Product/Process Change Notice (PCN)

PCN Number: PCN_UtRJ45LAN_20260720 Affected Series: WE-RJ45LAN Affected Part Number: see table "PART NUMBER, REVISION & DATASHEET" PCN Date: 2026-04-20 (YYYY-MM-DD) Effective Date: 2026-07-20 (YYYY-MM-DD)	Change Category: ☐ Equipment/Location ☐ General Data ☐ Material ☒ Process ☒ Product Design ☐ Shipping/Packaging ☐ Supplier ☐ Software
Contact: Product Management Phone: +49 (0) 7942 - 945 5001 Fax: +49 (0) 7942 - 945 5179 E-Mail: pcn.eisos@we-online.com	Datasheet Change: ☒ Yes ☐ No Attachment: ☐ Yes ☒ No

Before change	After change
Sideview of RJ45

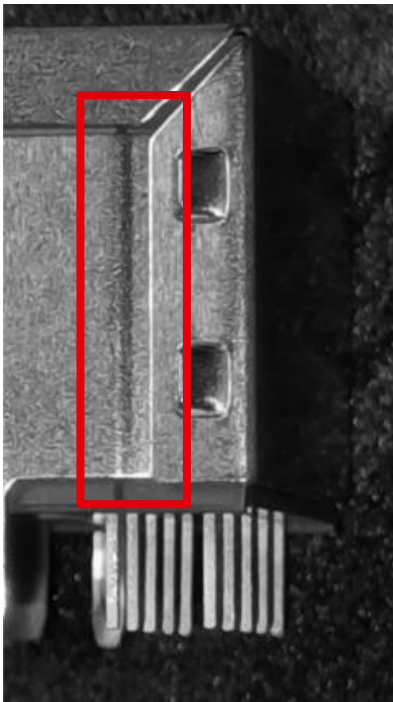
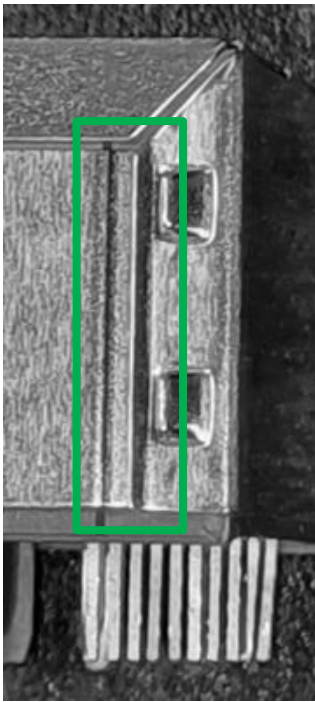
Due to an improvement of the production capability, Würth Elektronik eiSos will add a flanging to the shielding. There will be no change in fit, function, quality or reliability of the product.
